A47 Wansford to Sutton Dualling

Volume 9 **9.11 Road Safety Audits**

Stage 1 Road Safety Audit

Road Safety Audit Response

Figure 5-5: Eastbound approach to the proposed Peterborough Road link crossing

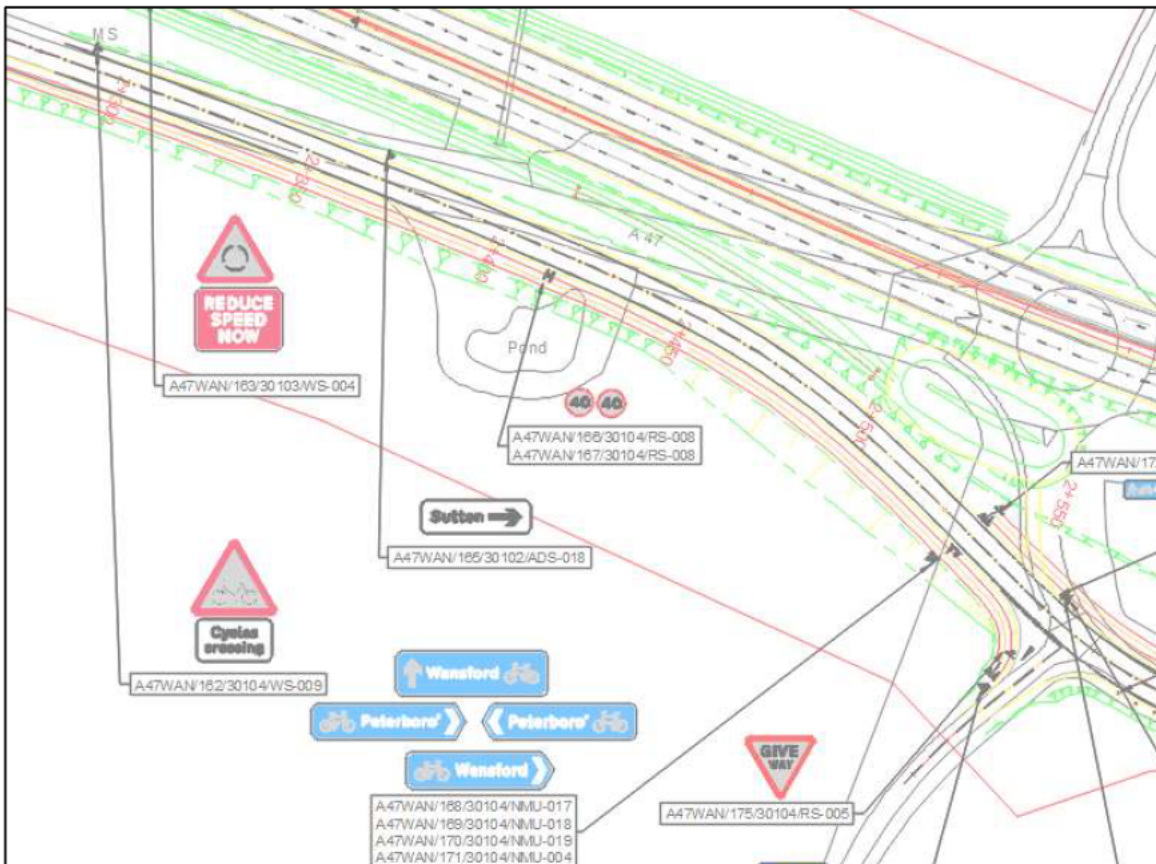
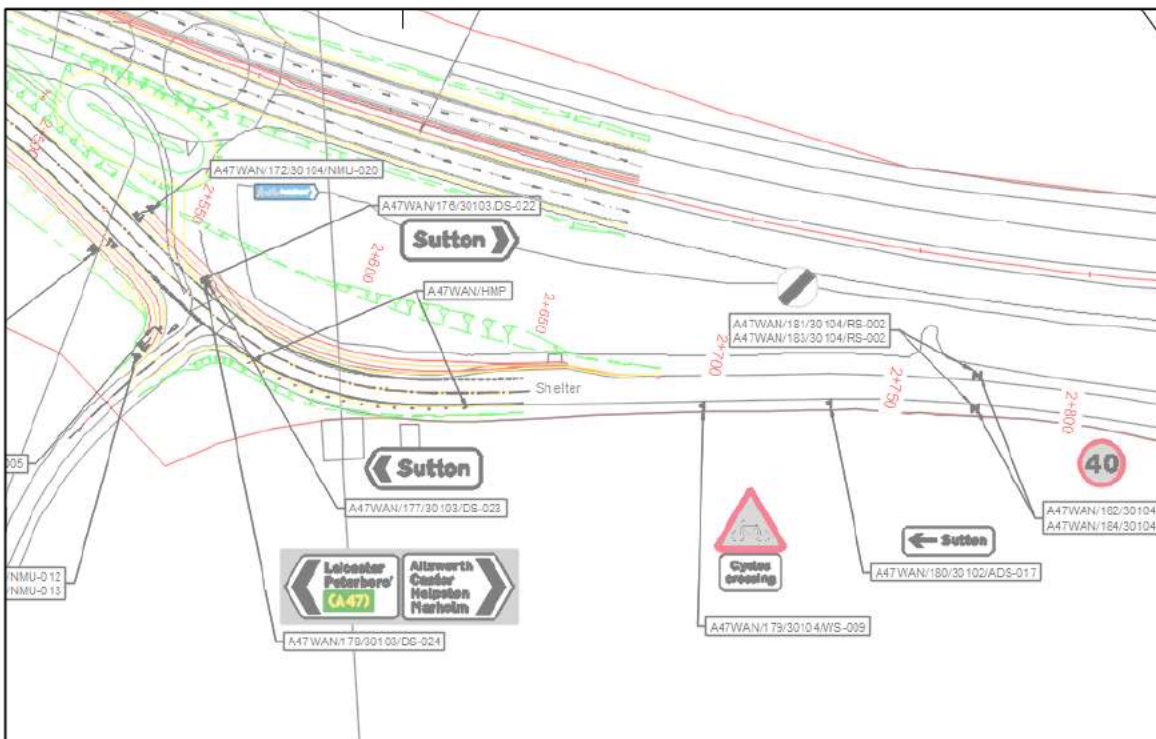
Problem 17	Location: Peterborough Road, near Nene Way (Drawing: HE551494-GTY-HMK-000-DR-CH-30007). Summary: Lack of sufficient crossing facilities leads to vehicle / NMU collisions. Description: An uncontrolled crossing for pedestrians and cyclists is proposed on the existing Peterborough Road, adjacent to Nene Way, which will connect shared foot / cycleway provision on either side of the carriageway. It is understood the speed limit will be 60mph and as a result there is concern that pedestrians and cyclists may encounter difficulty crossing the carriageway safely, with inherent vehicle / NMU conflict risk.	Ensure the design allows NMUs to safely cross Peterborough Road.	Disagree with problem: Crossing facilities with adequate visibility for the Design Speed (70kph) and Speed Limit (40mph) are proposed at this location, which will be supported by cyclists crossing warning signs are provided at each direction on the approach to the crossing point. These will be further developed at the detailed design stage.	Agree with Supplier Supplier to provide signage details as part of detailed design. Supplier to liaise with PCC Highways team regarding 40mph proposal.	Supplier to provide signage details as part of detailed design. Supplier to continue liaison with PCC Highways team regarding 40mph proposal.

Location: Link road to petrol station (drawing: HE551494-GTY-HMK-DR-CH-30003 and HE551494-GTY-HSN-000-DR-CH-30003).

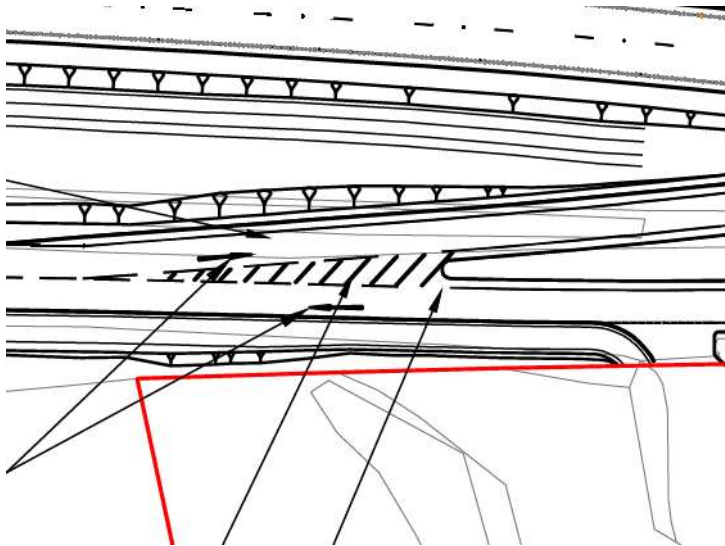
Recommendation: Provide traffic signing on the central island to advise drivers to proceed left around the one-way loop.

Problem 2	<p>Location: Link road to petrol station (drawing: HE551494-GTY-HMK-DR-CH-30003 and HE551494-GTY-HSN-000-DR-CH-30003).</p> <p>Summary: Lack of traffic signing to guide vehicles around the one-way system leads to head-on collisions.</p> <p>Description: On the proposed link road to the petrol station, a one-way loop road arrangement is to be provided. For eastbound traffic, the two opposing traffic movements are defined through use of arrow road markings and hatching alone that leads to a kerbed central island. No signing is proposed to reinforce the one-way system. If the road markings become less visible to a driver, for example due to poor weather conditions or deterioration of the markings, then drivers may inadvertently drive on the wrong carriageway, leading to head-on collisions.</p>	Provide traffic signing on the central island to advise drivers to proceed left around the one-way loop.	<p>Agree with problem and recommendation:</p> <p>Appropriate signing will be provided to resolve the problem in Detailed Design.</p>	Agree with Supplier and RSA problem.	Appropriate signing will be provided to resolve the problem in Detailed Design.

Location: Link road to petrol station (drawing: HE551494-GTY-HGN-000-DR-CH-36003)

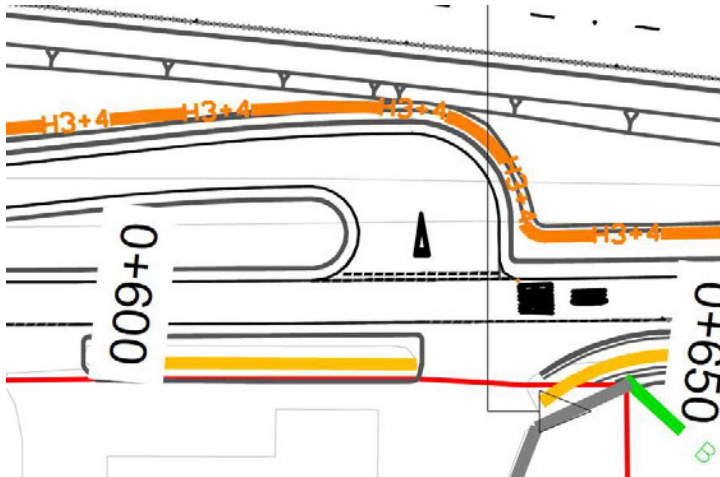
Description: New wooden post and rail fencing is proposed, which will follow the curvature of the northern side of the new loop road (see plan extract below). This fencing has the potential to restrict inter-visibility between drivers of the opposing movements, leading to side-on collisions between vehicles.

Recommendation: Ensure adequate inter-visibility is maintained between all potentially conflicting vehicular movements.

Problem 3	<p>Location: Link road to petrol station (drawing: HE551494-GTY-HGN-000-DR-CH-36003)</p> <p>Summary: Proposed fencing blocks inter-visibility between opposing traffic movements.</p> <p>Description: New wooden post and rail fencing is proposed, which will follow the curvature of the northern side of the new loop road (see plan extract below). This fencing has the potential to restrict inter-visibility between drivers of the opposing movements, leading to side-on collisions between vehicles.</p>	Ensure adequate inter-visibility is maintained between all potentially conflicting vehicular movements.	<p>Agree with problem and recommendation:</p> <p>Fencing design to be amended in detailed design to ensure adequate visibility.</p>	Agree with Supplier and RSA problem.	Fencing design to be amended in detailed design to ensure adequate visibility.
Problem 4	<p>Location: Existing petrol station and new link road (Drawing: HE551494-GTY-HSN-000-DR-CH-30004).</p> <p>Summary: Proposed traffic signing for petrol station may lead to large vehicles trying to enter the petrol station and having to reverse back onto the highway.</p> <p>Description: The existing petrol station is to be retained within the scheme and is to be provided with access from the westbound A47 carriageway and from a new link road, to the south of the mainline. The existing forecourt was observed to be constrained in space and unsuitable for large vehicles. The petrol station is to be signed as 'services' by means of traffic signs located on the east and westbound A47 carriageway. The proposed wording of the traffic signs does not give any indication of the size of the petrol station, or the facilities available and could raise driver expectation that there is a large facility available. This could lead to large vehicles trying to enter the forecourt and potentially having to reverse back onto the link road or stop-start on the link road, leading to shunt type collisions. This is likely to be</p>	Provide traffic signing appropriate for the petrol station facility and the vehicle-types it can accommodate.	<p>Agree with problem and recommendation:</p> <p>Appropriate signing will be provided to resolve the problem in Detailed Design.</p>	Agree with Supplier and RSA problem.	Appropriate signing will be provided to resolve the problem in Detailed Design.

Location: Existing petrol station and new link road (Drawing: HE551494-GTY-HSN-000-DR-CH-30004).

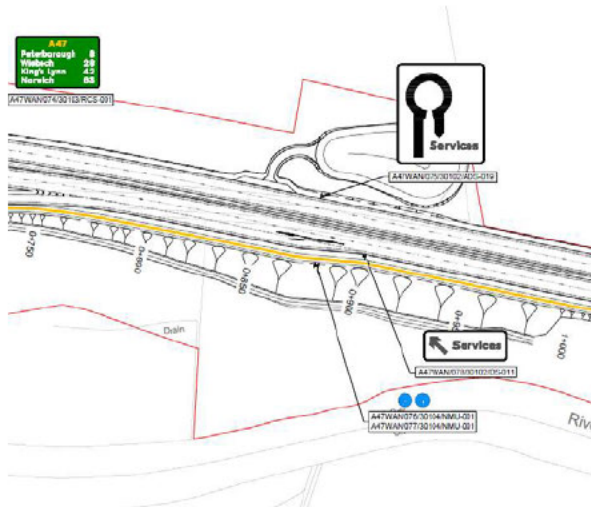
Recommendation: Provide traffic signing appropriate for the petrol station facility and the vehicle-types it can accommodate.

Location: Upton Drift Road (Drawing: HE551494-GTY-HGN-000-DR-CH-36005)

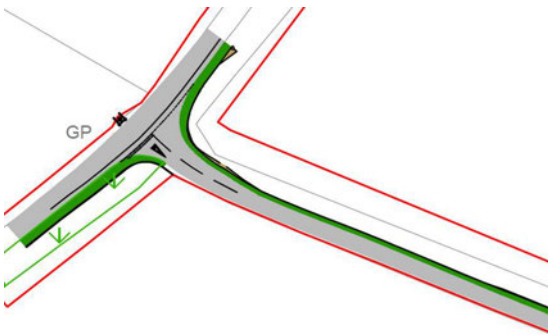
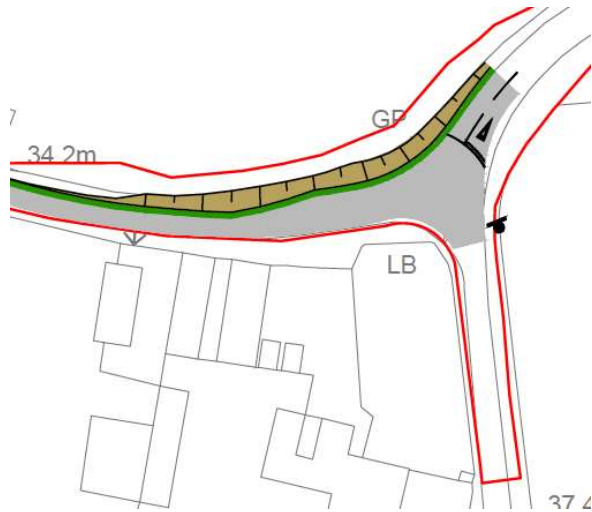
Description: It is proposed that Upton Drift Road is retained as a single-track road, with new passing bays provided. The proposed passing bays are positioned towards the central section of the road, some distance from the junctions at either end of Upton Drift Road. A vehicle turning into Upton Drift Road, at either end, may face an on-coming vehicle and have no safe place to pull into, to allow passing. This could lead to vehicles reversing or blocking the junctions, with the potential for resultant shunt or side-swipe collisions.

Recommendation: Provide two lanes, of sufficient length for large vehicles to safely pull into, at the junctions at either end of Upton Drift Road.

Reference	RSA problem	RSA recommendation	Design organisation response	Overseeing Organisation response	Agreed RSA action
	exacerbated by the potential high speeds of vehicles entering the slip road that leads to the petrol station.				
Problem 5	<p>Location: Upton Drift Road (Drawing: HE551494-GTY-HGN-000-DR-CH-36005)</p> <p>Summary: Lack of passing places leads to head-on collisions.</p> <p>Description: It is proposed that Upton Drift Road is retained as a single-track road, with new passing bays provided. The proposed passing bays are positioned towards the central section of the road, some distance from the junctions at either end of Upton Drift Road. A vehicle turning into Upton Drift Road, at either end, may face an on-coming vehicle and have no safe place to pull into, to allow passing. This could lead to vehicles reversing or blocking the junctions, with the potential for resultant shunt or side-swipe collisions.</p>	Provide two lanes, of sufficient length for large vehicles to safely pull into, at the junctions at either end of Upton Drift Road.	<p>Agree with problem and recommendation:</p> <p>Sufficient length for large vehicles to safely pass at the junctions at either end of Upton Drift Road will be provided in Detailed Design.</p>	Agree with Supplier and RSA problem.	Sufficient length for large vehicles to safely pass at the junctions at either end of Upton Drift Road will be provided in Detailed Design.
